PROPOSED CHANGE NO. SC-01-002R1

Date: July 24, 2025
File: 9.1.7.4.2_SC-01_PC
Project No.: 2215C
Project: TA Blakelock HS Reno - Phase 3
Subcontract: SC-01 General

Description: Elevator 2 (drama area)

CONTEMPLATED CHANGE NOTICE No. S1

5 PARTIAL FLOOR PLAN - LEVEL 1 & 1A
A100 1:50

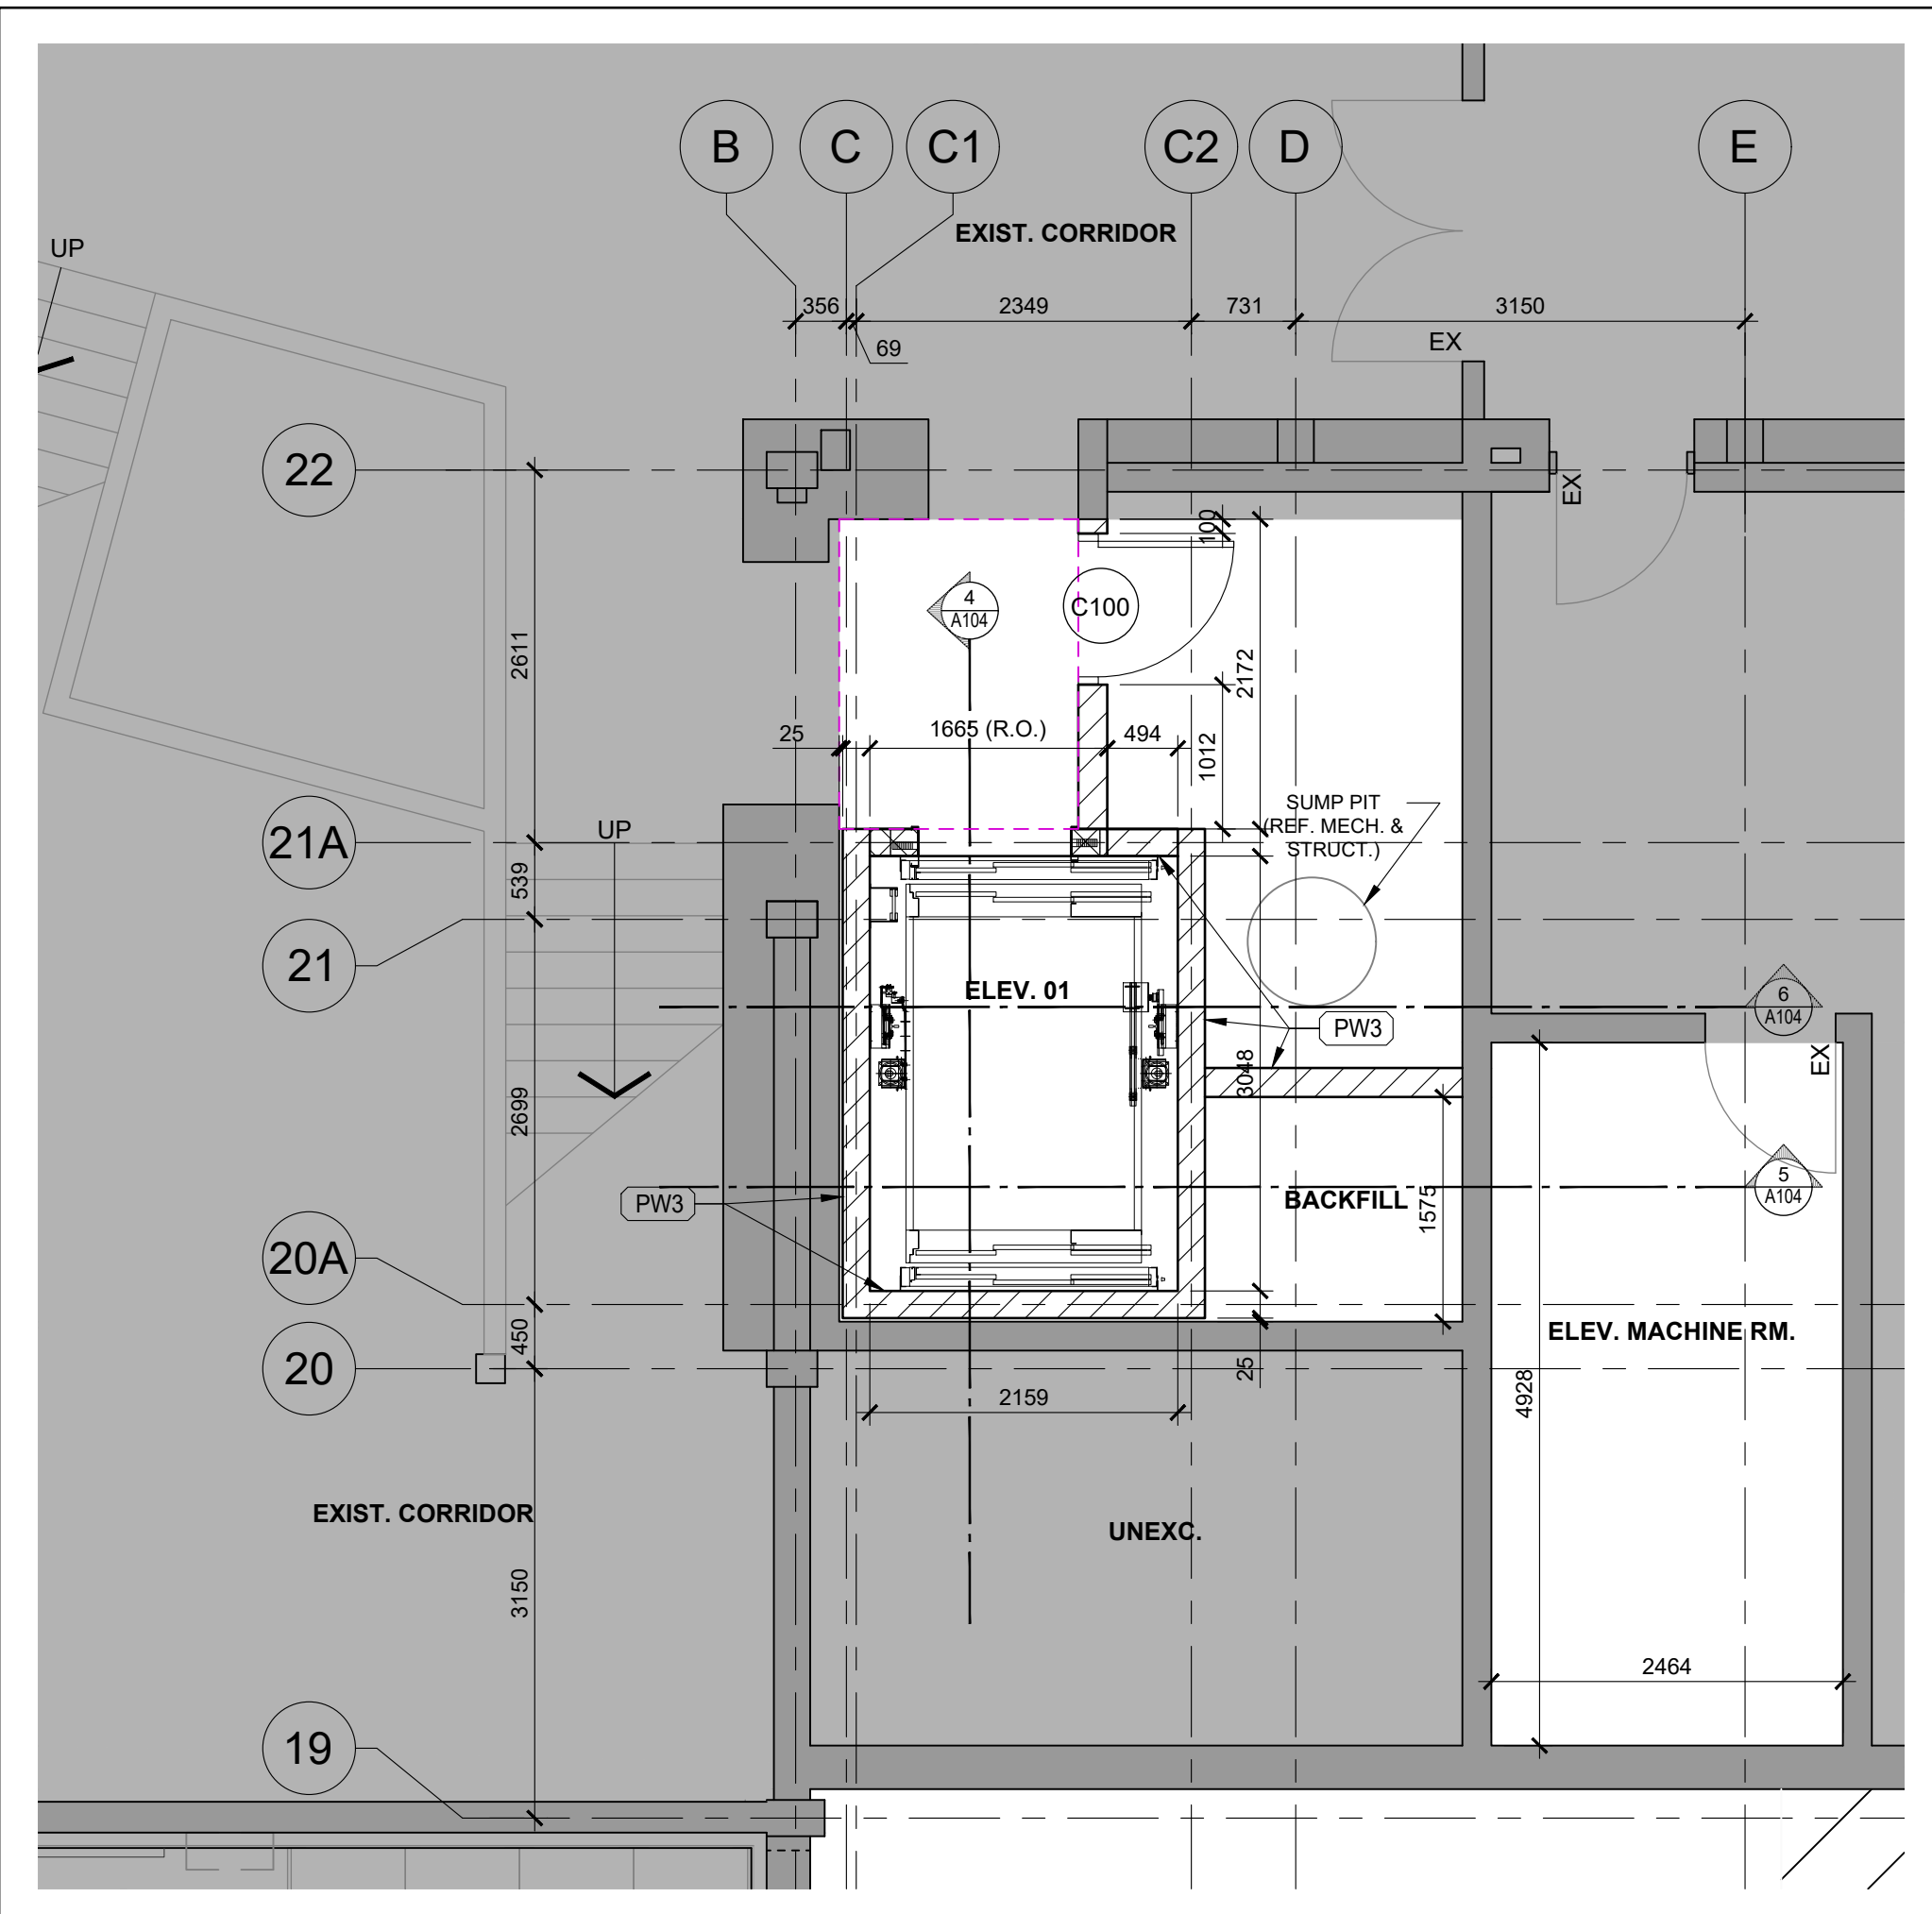
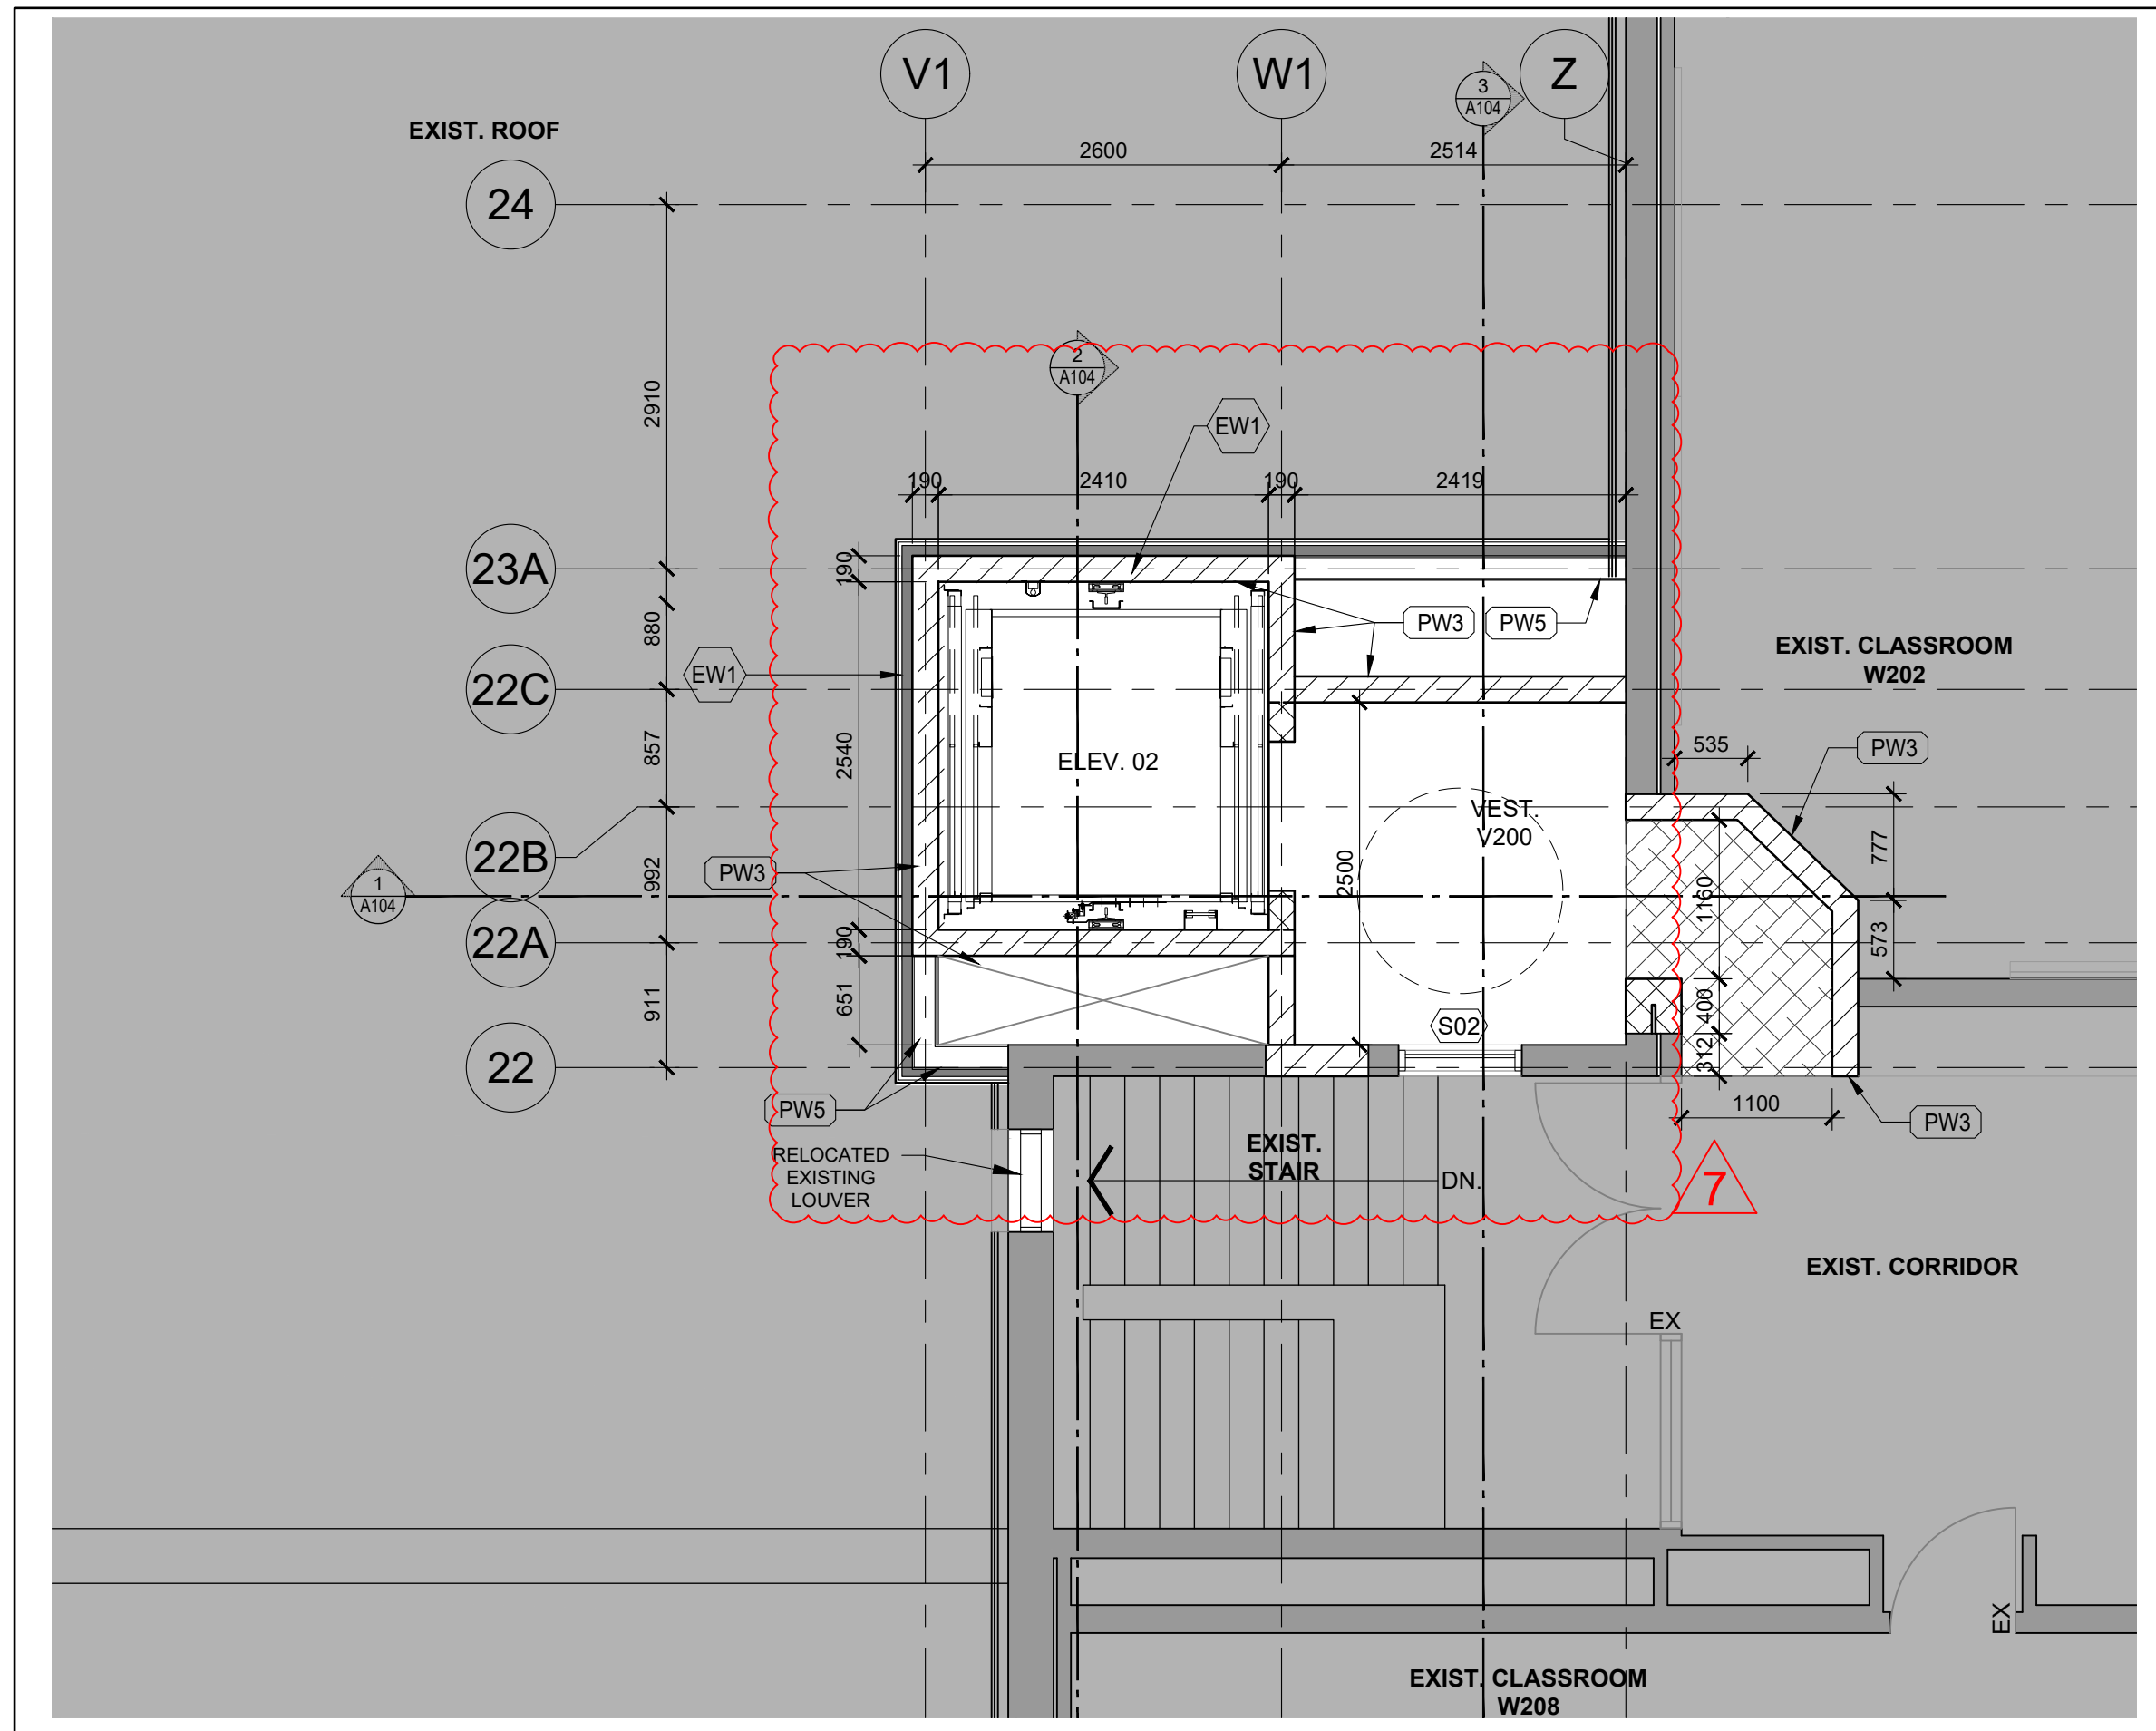
1. Refer to attached updated A100 floor plans and A104 updated sections.
2. Refer to Structural CONTEMPLATED CHANGE NOTICE No. S1 item 1 for requirements.
3. Mechanical CCN to follow adjusting sump pit location and corresponding drainage and piping to it. Electrical CCN to follow confirm power and control until location for sump pit.
4. Refer namely to sump pit relocation, deletion of underpinning along West side of Drama Room (Refer to Structural CCN for scope).
5. Provide 36x 36 ACUDOR FT-8050 concrete floor door, single leaf, 1" recessed to receive flooring. Provide cut sheet. Note this ACUDOR is intended to clear the 24" dia sump pit including sump pit flange. Confirm with vendor. Set sump pit lid just at u/s of lid opening. Provide cut sheet of ACUDOR. Run sump pit venting and discharge line within adjacent 190mm CMU wall.
